This proposal was elaborated in the Task Force - head restraint height measuring method, together with OICA members and it aims on improving the method of measuring the height of head restraints.

MINIMUM HEIGHT MEASUREMENT TEST PROCEDURE USING THE R-POINT METHOD

Figure 1-1

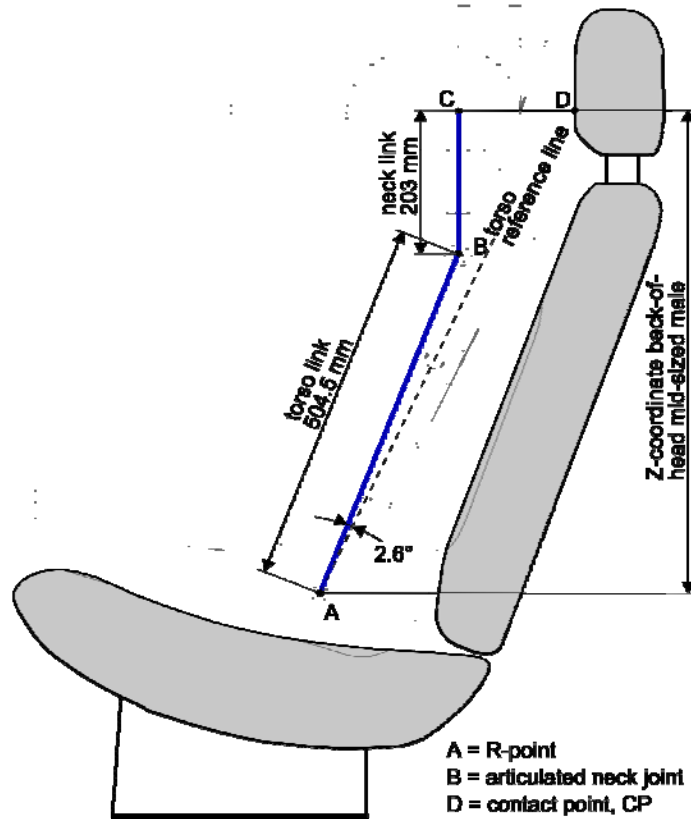
The height measurement apparatus consists of **is based on the usage of apparatus that facilitate the measurement of coordinates** (see Figure 1-1):.

CP is determined being the intersection of a horizontal line, on the height of the Z-coordinate of the back-of-head of the mid-sized male (as provided by table 1), with the front surface of the head restraint as indicated in Figure 1-1.

Figure 1-2

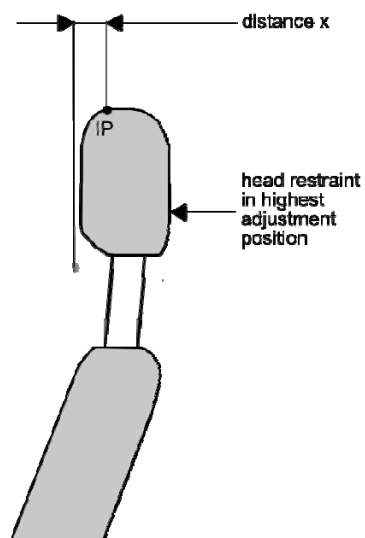
IP is determined on the front surface of the head restraint as the intersection with a vertical line rearwards of CP (see Figure 1-2) at the “distance x” (as provided by table 1).

Figure 1-3

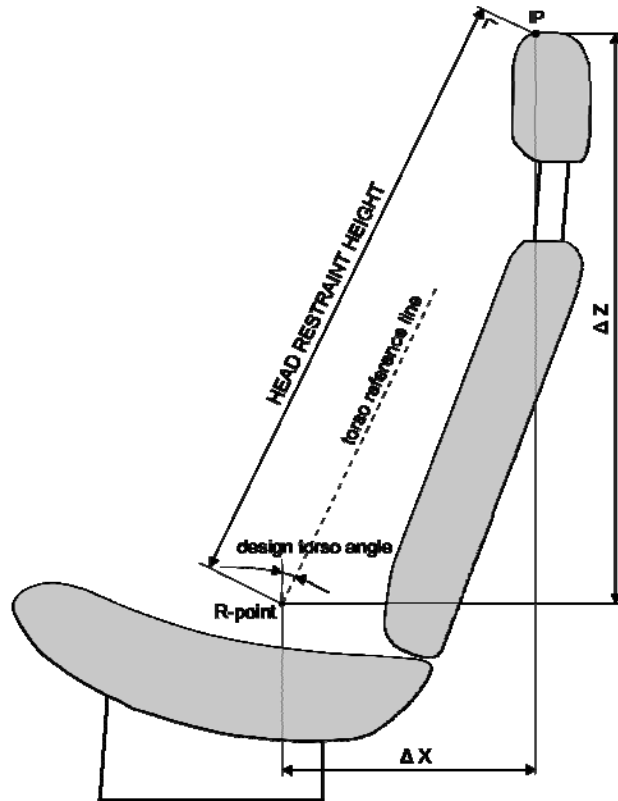
The head restraint height is the distance from the R-point, parallel to the torso reference line and limited by a line perpendicular to the torso reference line intersecting IP (see Figure 1-3).

After the coordinates of IP are determined, the highest head restraint height can be calculated by its longitudinal (ΔX) and vertical (ΔZ) distance from the R-point (see Figure 1-3), as follows:

$$\Delta X \cdot \text{SIN}(\text{design torso angle}) + \Delta Z \cdot \text{COS}(\text{design torso angle})$$

Figure 1-4

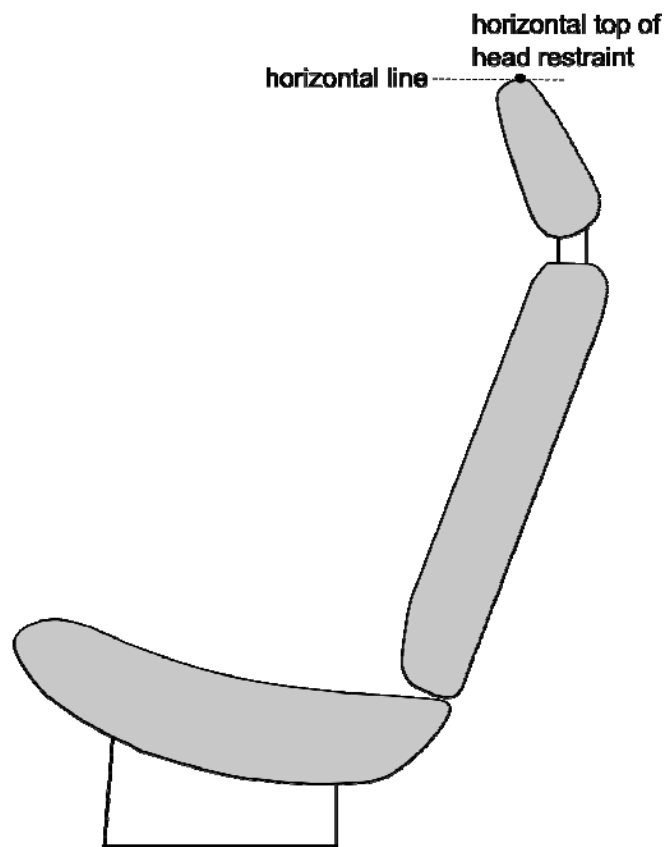
[In the case even this will not produce a point of intersection, both CP and IP will be appointed at the horizontal top of the head restraint (see Figure 1-4).]

Where IP would be located rearwards of the horizontal top of the head restraint, IP will be appointed at the horizontal top of the head restraint (see Figure 1-4).
